This informal document is submitted by the Informal Working Group (IWG) Particle Measurement Programme to inform and update the GRPE of the work of the IWG on the amendment of UN GTR 15 Annexes 5, 6, 7 to:

- Modify the existing solid PN measurement methodology having a 50% cut-off size at 23 nm (SPN23) in order to allow the use of catalyzed volatile particle remover (VPR) and introduce minor improvements
- Include as a second option a solid PN measurement methodology with a 65% cut-off size at 10 nm (SPN10).

This is the consolidated document addressing the changes to the current methodology and the proposed changes for the second options to extend the particle size detection range to 10 nm.

Figure A5/14a

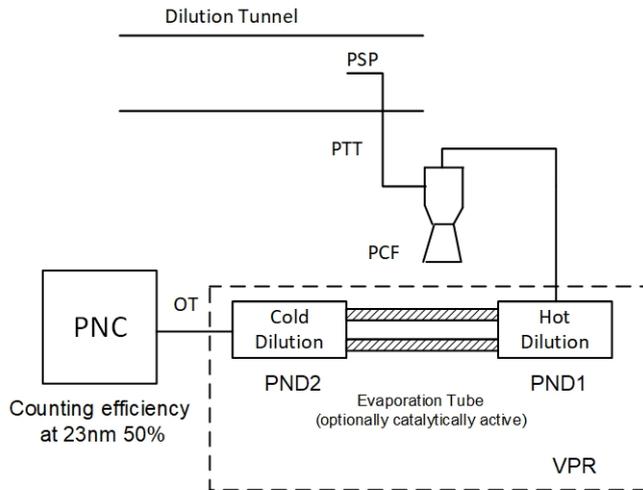
SPN 23:

4.3.1.4.1.3. SPN23:

The evaporation tube, ET, may be catalytically active.

Figure A5/14b

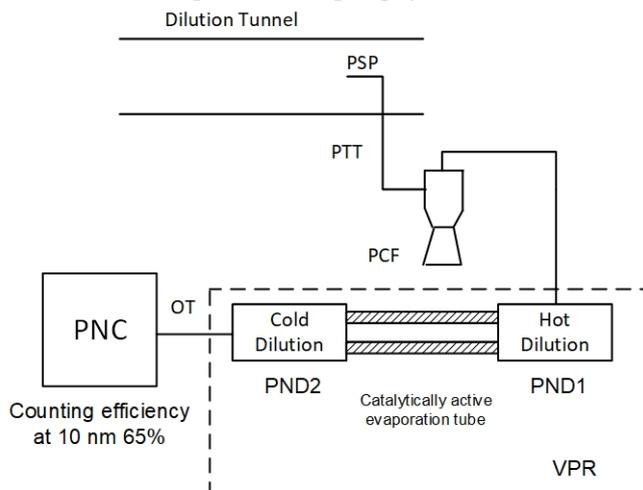
SPN10:

SPN10:

The evaporation tube, ET, shall be catalytically active.
